CITY OF ALBUQUERQUE

**RE: 355 Manuel Sanchez Place SW
Grading and Drainage Plan
Engineer's Stamp Date: 10/12/22
Hydrology File: K12D025**

Based upon the information provided in your submittal received 10/13/2022, the Grading & Drainage Plan is approved for Grading Permit (earthwork can get started for the earth pad on the house).

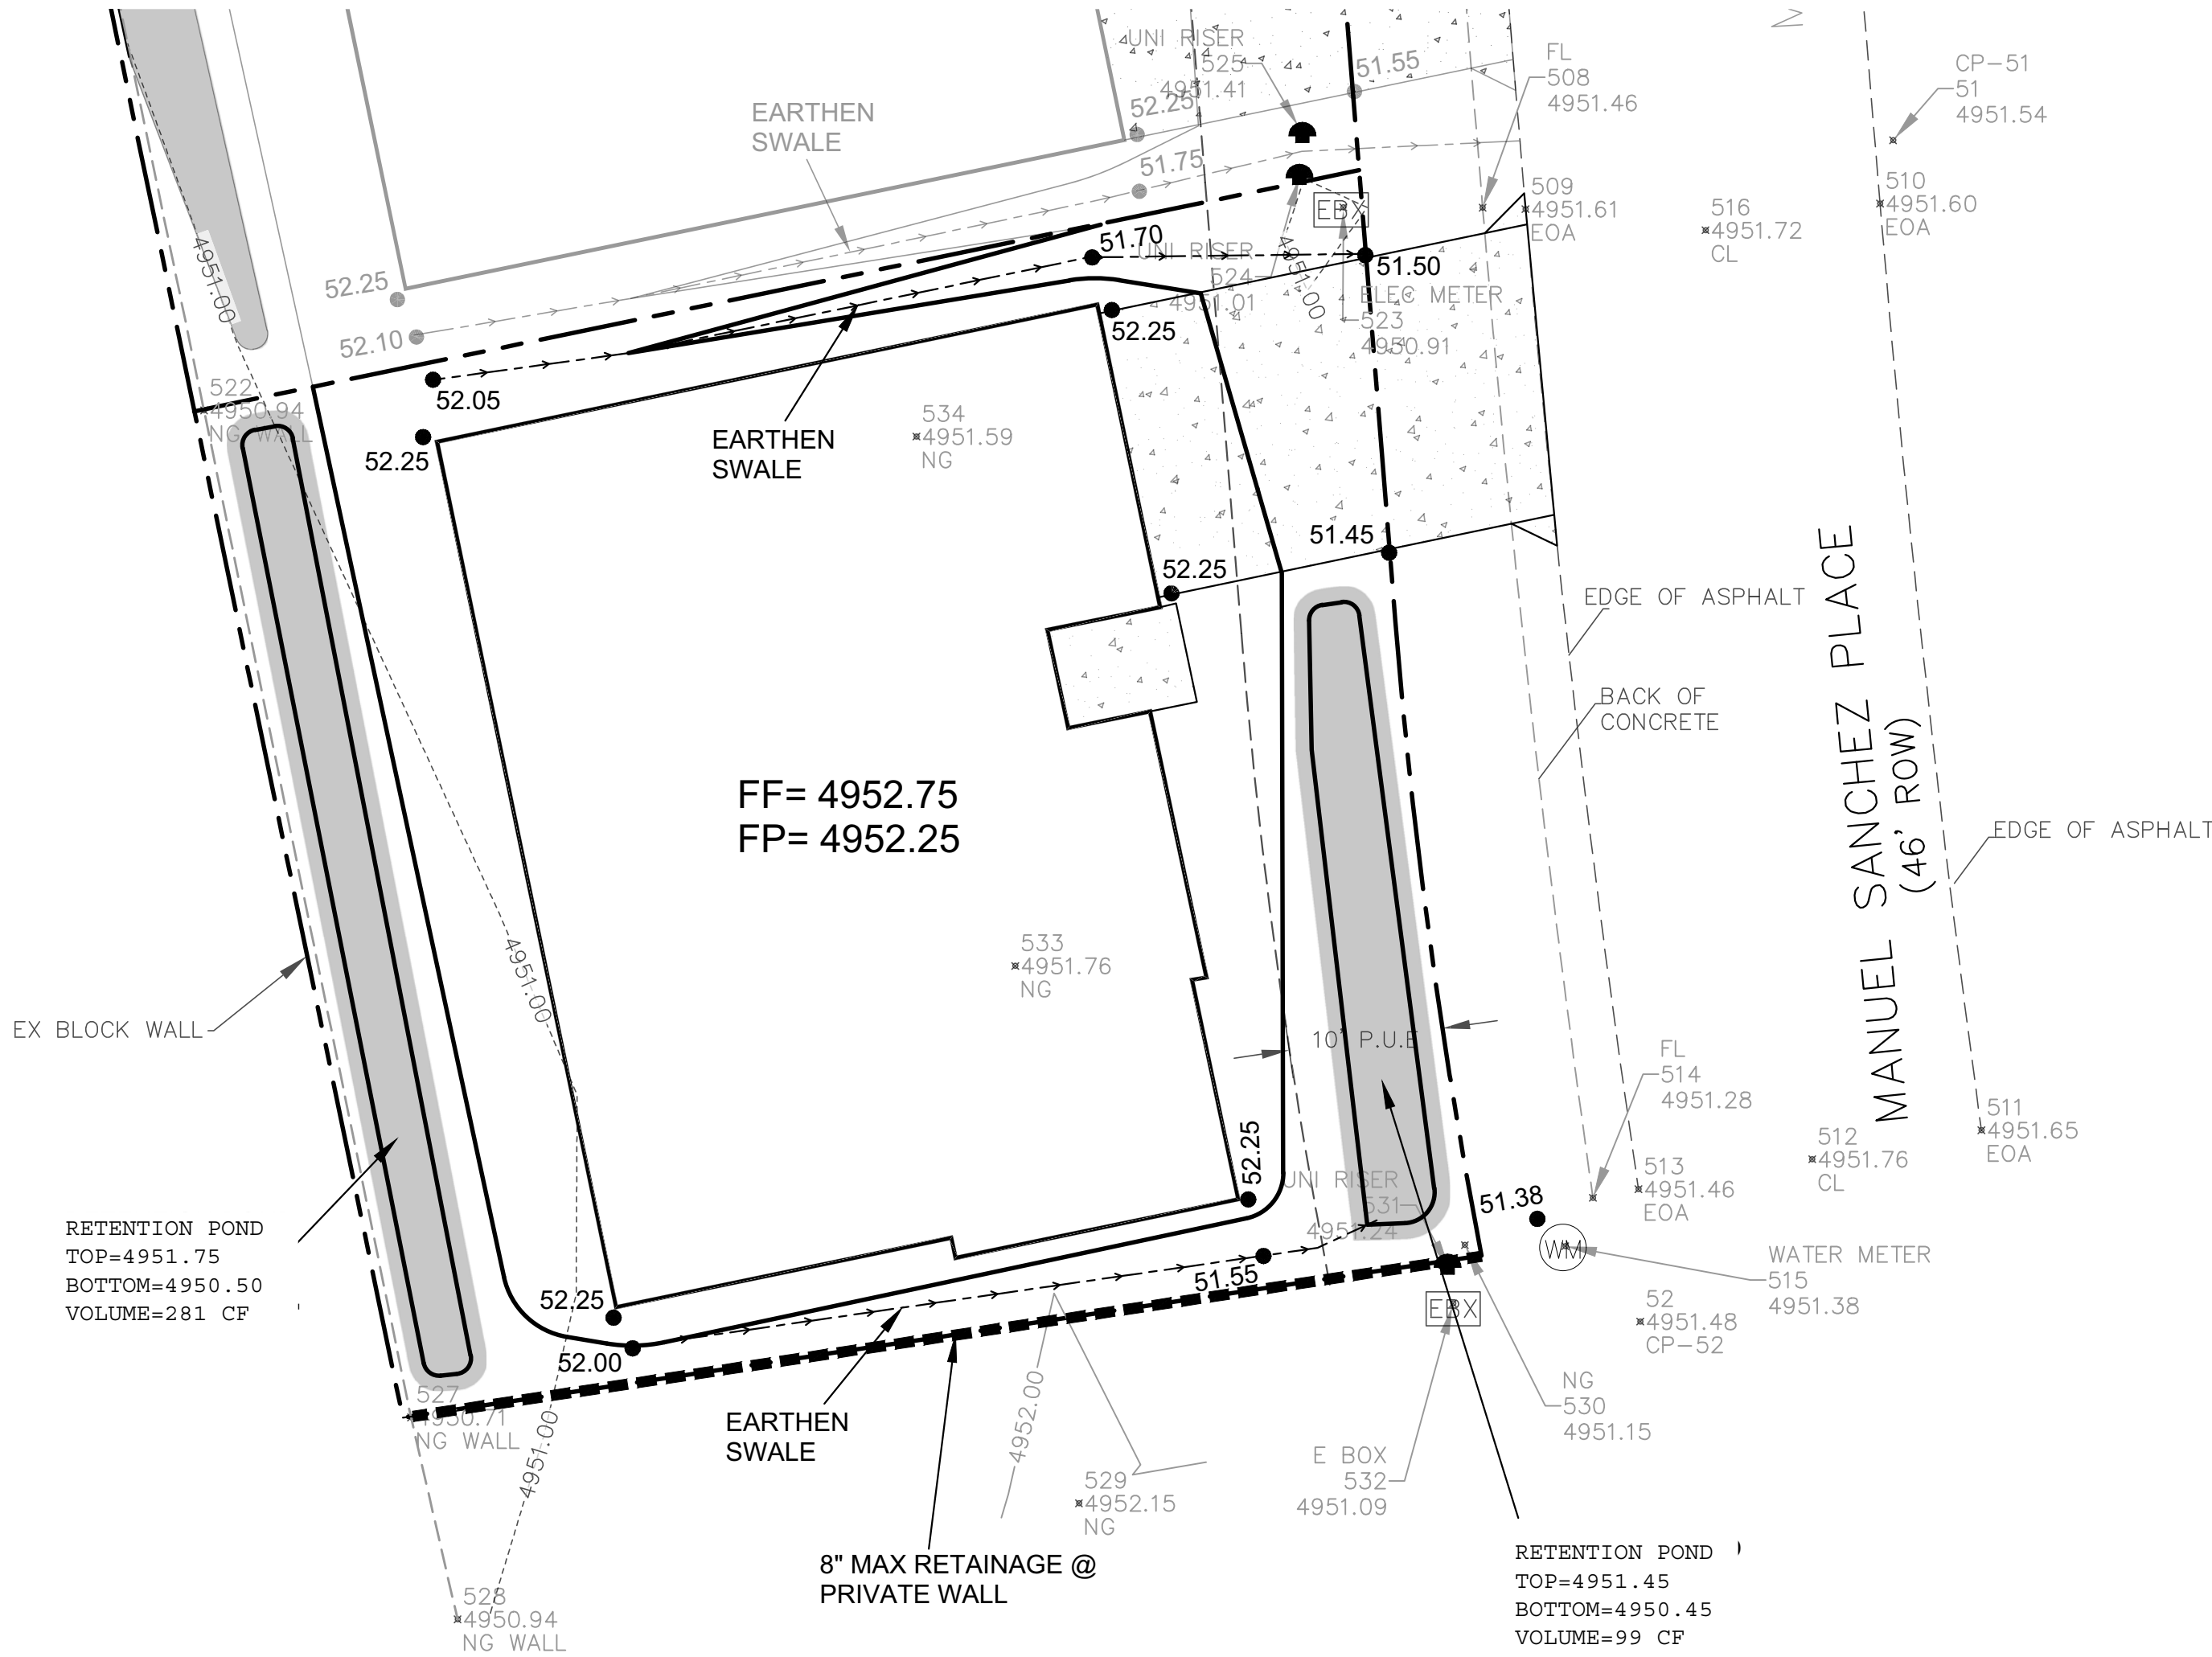
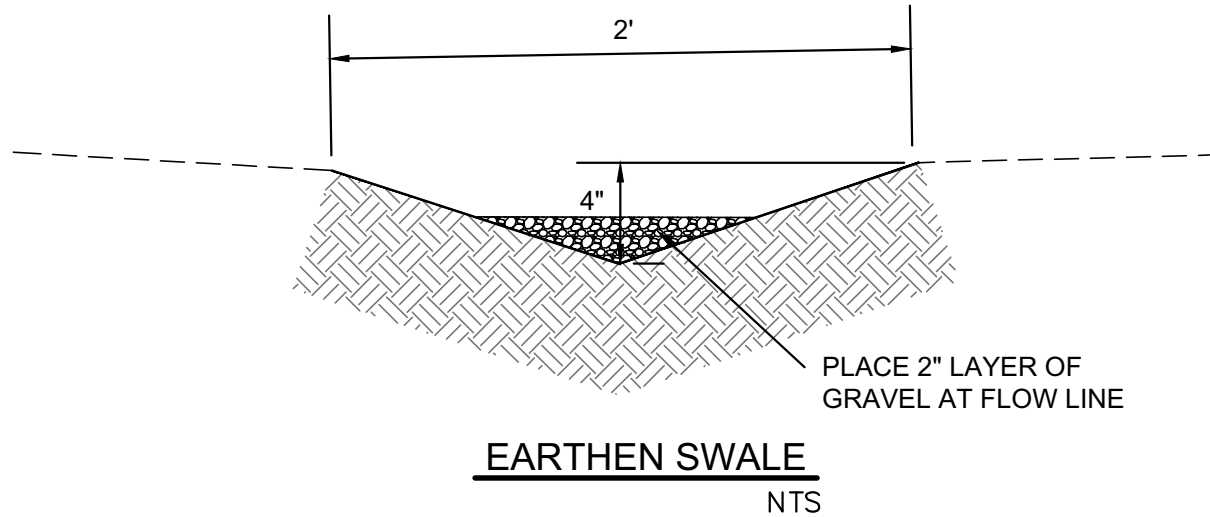
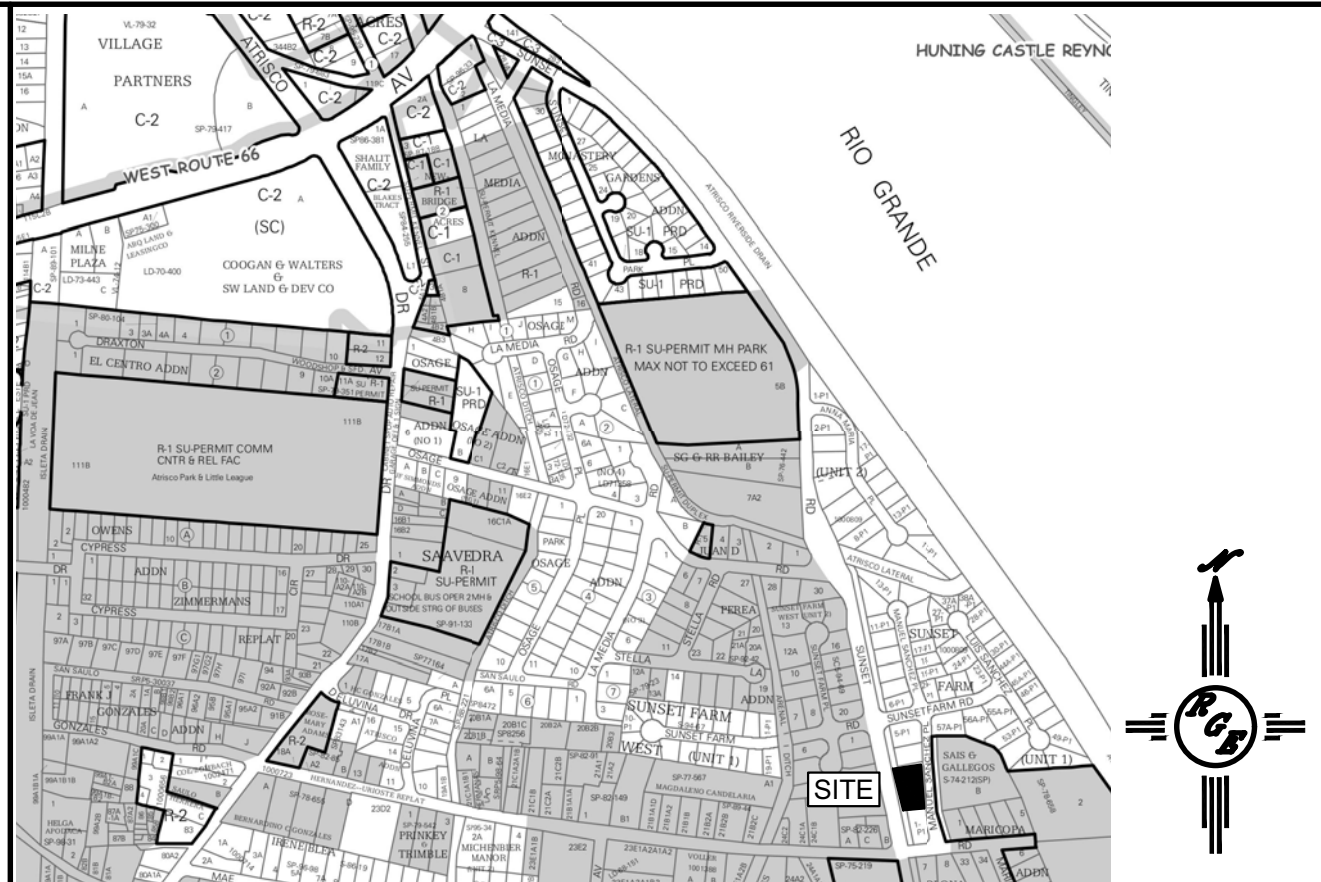
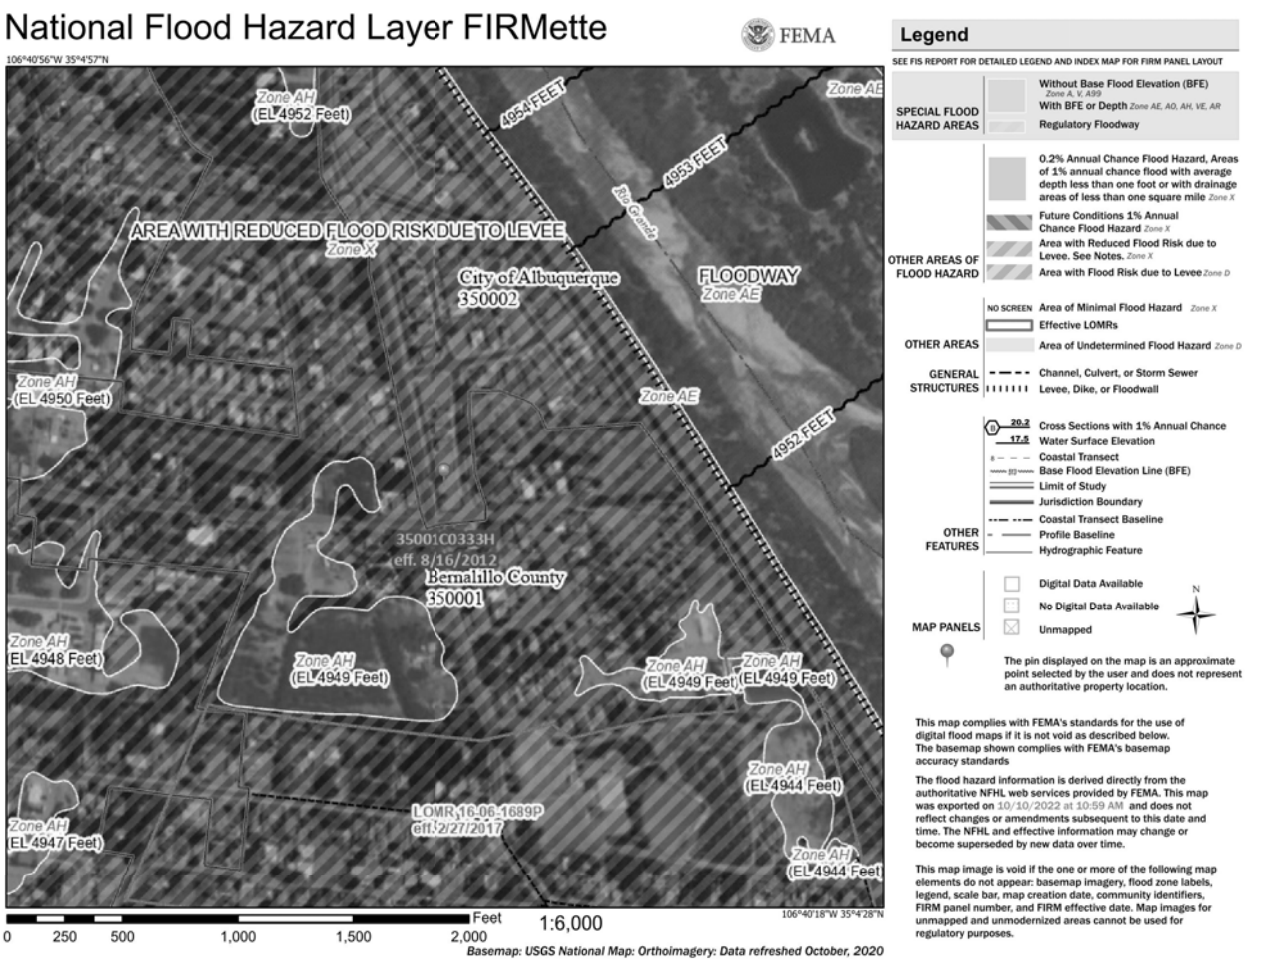
1. Once the grading is complete, a pad certification (meaning that the earthwork is complete) will be required. Please include a site photo with the submittal. Also, at the time of pad certification approval, Hydrology will concurrently approve the Grading & Drainage Plan for Building Permit.
